**DEFENSE NUCLEAR FACILITIES  
SAFETY BOARD**

## Staff Report

### **Safety Posture of the Principal Underground Laboratory for Subcritical Experimentation and Associated Major Modification Projects**

**Figure 2.** *Potential impact of faults within PULSE, displacing drifts and triggering earthquake vibrations.*

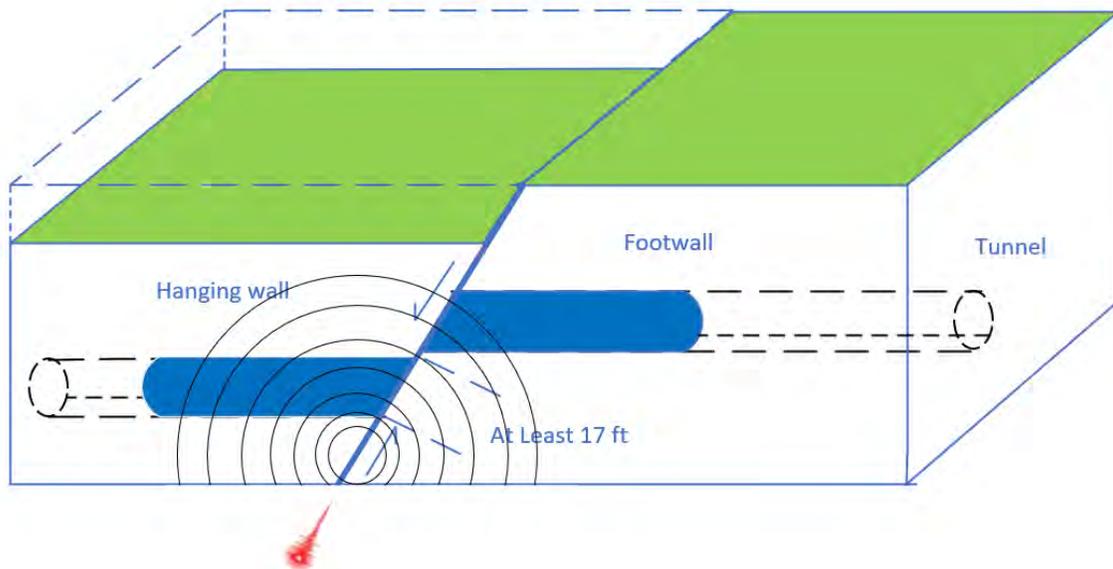
The safety design basis documents for the ECSE projects do not analyze a fault displacement hazard scenario. NNSS personnel consider this scenario to be bounded by the analyzed scenario in which a seismic event results in overhead equipment falling onto a subcritical experiment package [2]. The safety design basis documents credit the shipping container to protect the subcritical experiment. The magnitude of a fault displacement is typically proportional to the dimension of the faults [11]. Given that the dimensions of the faults in PULSE are uncharacterized, the potential magnitude of the fault displacement event is unknown but could potentially be 17 feet or greater (Figure 2). The shipping container may not be able to fully protect the subcritical experiment from a severe displacement. As a result, the ECSE safety basis documentation should analyze this event separately as a unique hazard.

Because the PULSE faults are not included in the USGS database, all NNSS facilities (e.g., DAF) may be underestimating the seismic hazard. Also, important NNSS infrastructure, such as highways and electrical transmission lines, could be potentially severed due to fault displacement.

**Figure A-1.** Fault distribution within PULSE [10]. Solid red lines indicate observed faults and dashed red lines indicate inferred faults.

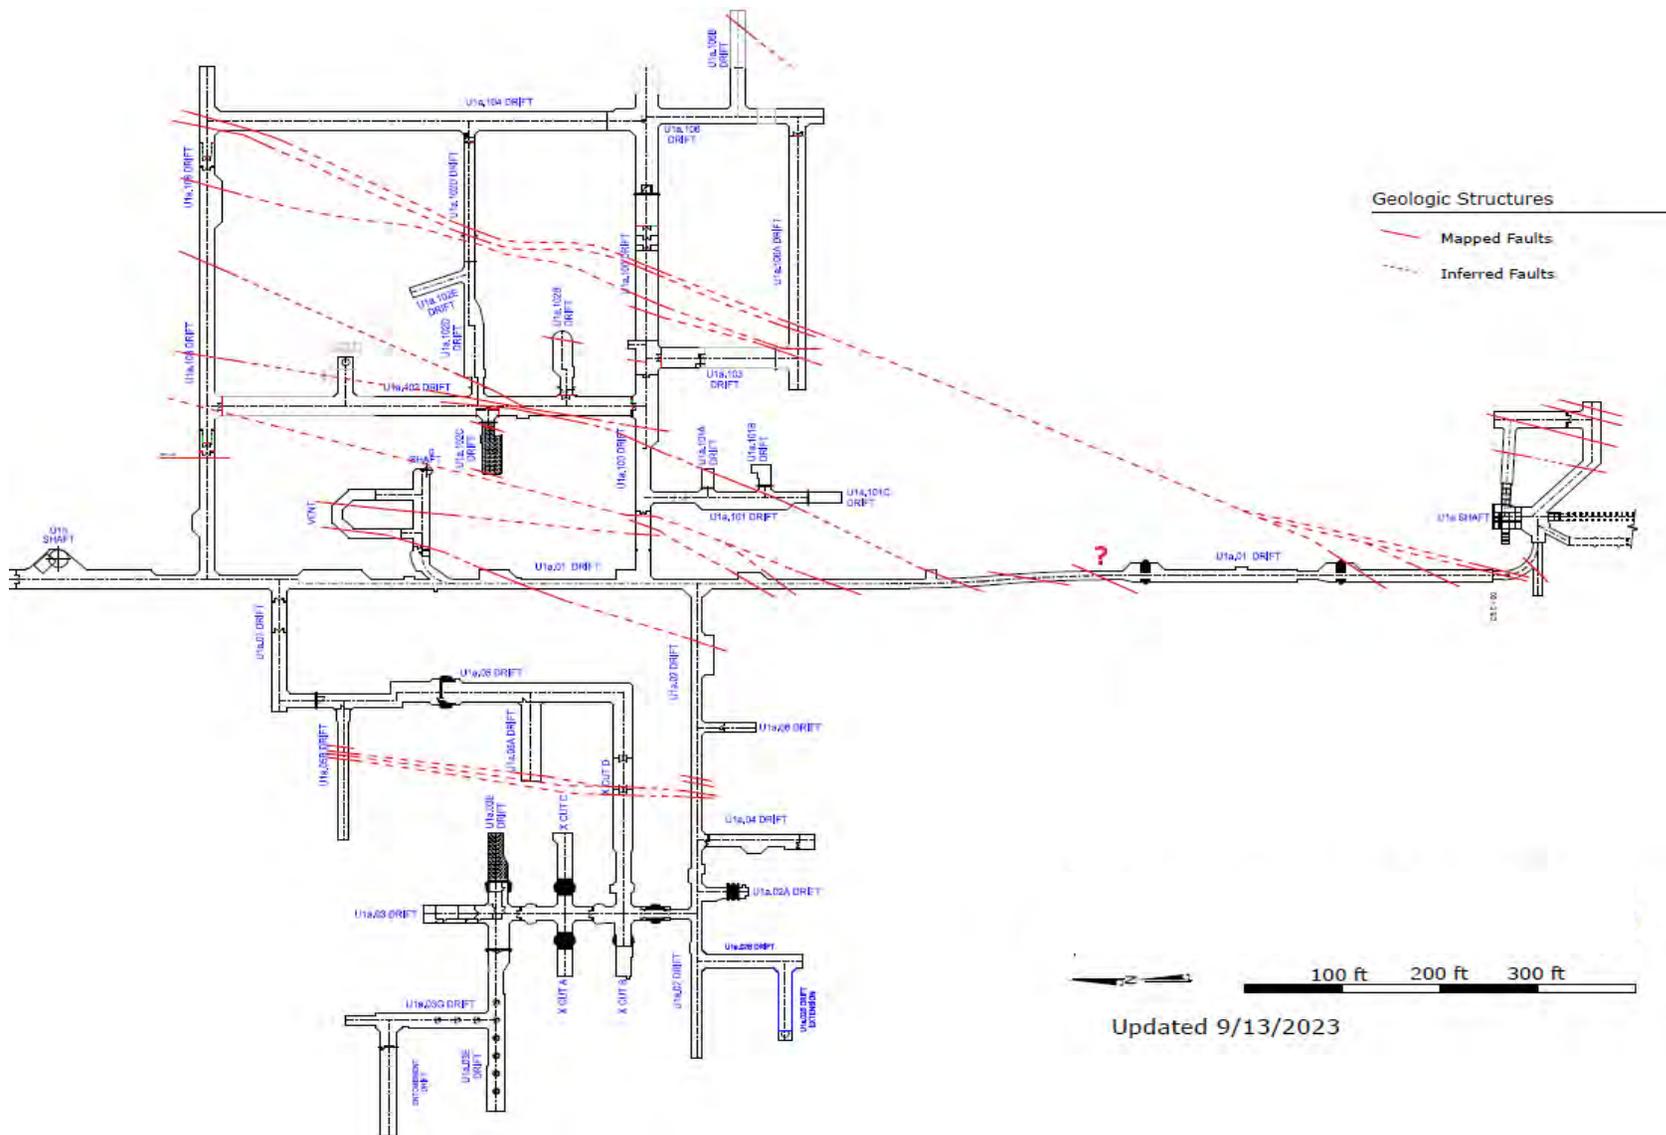
**Extensive Presence of Seismic Faults within PULSE.** Seismic faults are extensively exposed within the tunnels with more than 50 individual locations based on the fault distribution map (Figure A-1). These faults are primarily normal faults. In this type of fault, the block above the fault line moves downward relative to the block below (Figure A-2). The faults observed in the U1a.01 drift predominantly strike in a north-south or northeast direction with a dipping angle of approximately 80 degrees, consistent with the descriptions in NNSS geological reports.

Although these faults are dispersed across various tunnel sections and not directly interconnected, they are part of the fault system, as some can be linked to form longer faults based on their orientations and fault types. The longest ones can potentially extend more than 1,000 feet (Figure A-1). These faults also have displacements of more than 17 feet, which exceeds the height of the tunnels in the drifts east of the U1a.01 drift [6]. Fault displacements west of the U1a.01 drift are relatively smaller, less than the height of drifts. Polished surfaces (termed “slickensides”) and rocks formed by grinding (termed fault gouges) due to movement along both sides of faults are common, indicating previous earthquake activity (Figure A-3). The staff team’s walkdowns within the tunnels affirmed the descriptions including the fault orientations and attitudes provided in the NNSS reports [6–9].

**Figure A-2.** *NNSS Photo [7] shows that a nearly vertical fault displaced sedimentary layers. Fault line is indicated with a red line. Note that the nearly horizontal sedimentary layer with gravels at the bottom left was discontinued near the red line.*

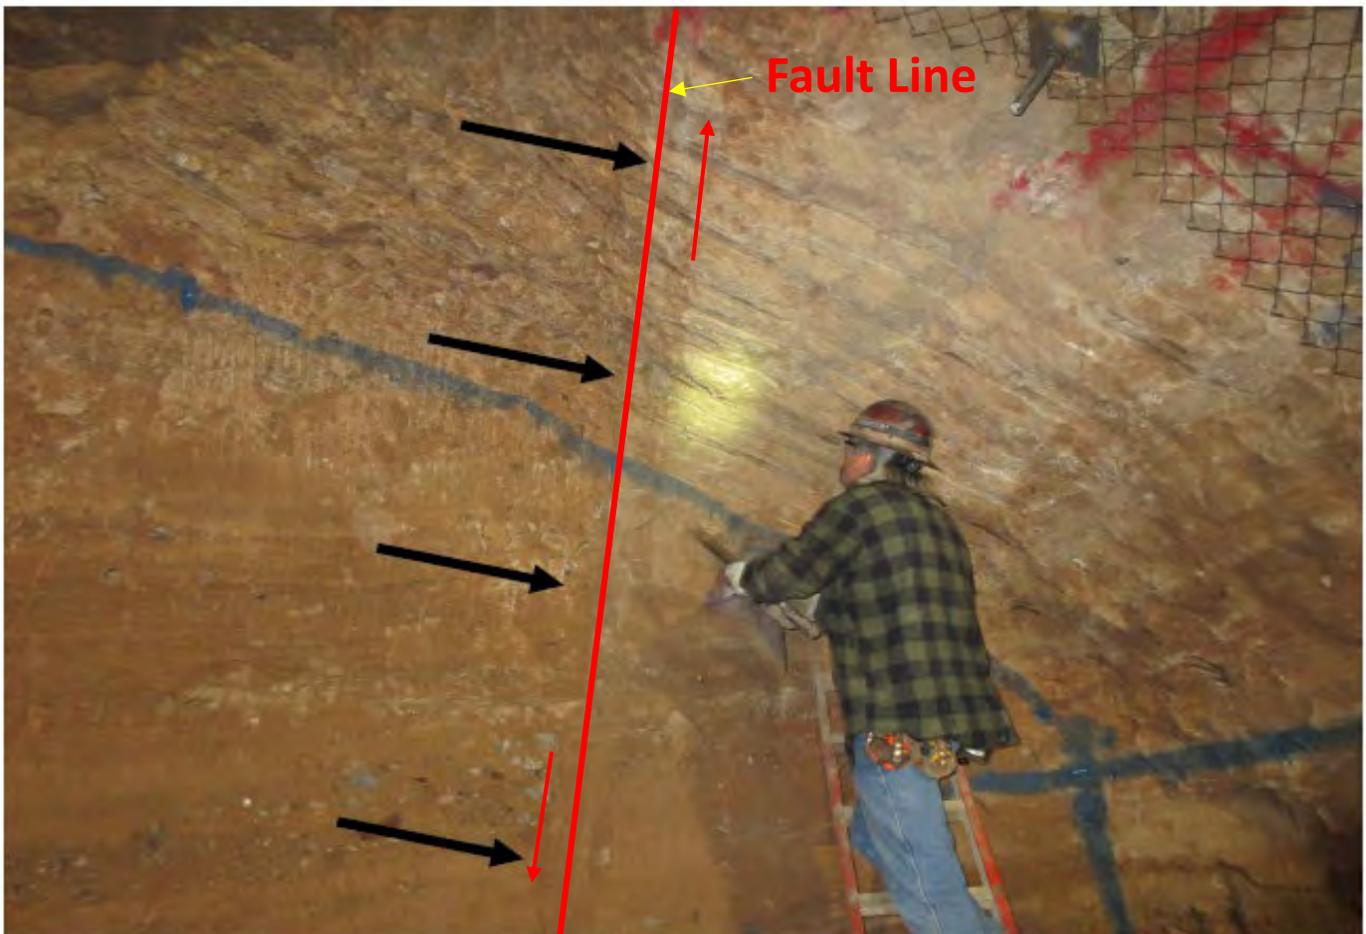
Even if the ash layer was deposited in the Tertiary period, that would not mean faulting necessarily occurred in the Tertiary period. This is because evidence from NNSS geological reports [6–9], along with observations during the staff team’s walkdowns, indicate that the faults within PULSE not only displaced the ash layer but also displaced alluvium layers younger than the ash layer, extending beyond the tunnel ceiling. These faults could terminate anywhere between immediately above the tunnel ceiling and the ground surface. In undisturbed sedimentary layers, the younger sedimentary layers are closer to the surface. This suggests that the age of the faults within the tunnel could be younger than the age of the tunnel-level deposits they displaced and older than the present ground surface, which they did not penetrate.

**Figure A-4.** *Potential impact of faults within PULSE, displacing drifts and triggering earthquake vibrations.*

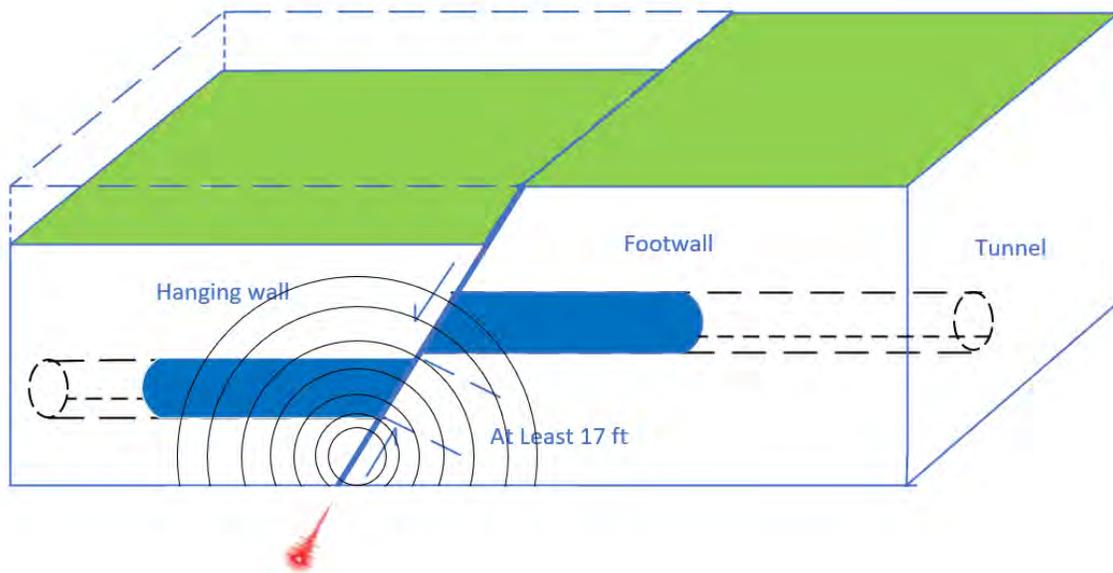
The magnitude of the fault displacement is typically proportional to the dimension of the faults [11]. Given that NNSS personnel have not characterized the dimensions of the faults in PULSE (e.g., the faults could extend to the north or south for many miles), the potential magnitude of the fault displacement event is unknown. Additionally, normal faulting events could displace the underlying layers, which could consist of various hard rocks. If a more severe displacement were to occur, then the shipping container may not be able to fully protect the

subcritical experiment (Figure A-4). As a result, the ECSE safety basis documentation should analyze this event separately as a unique hazard.

In addition, due to the exclusion of PULSE faults in the U.S. Quaternary Fault and Fold Database, all NNSS facilities that use the National Earthquake Hazard Maps as a basis to determine their seismic design may potentially be underestimated. This includes all NNSS facilities with SDC-1 and SDC-2 structures, systems, and components. Important NNSS infrastructure, such as highways and electrical transmission lines, could be potentially severed due to fault displacement.
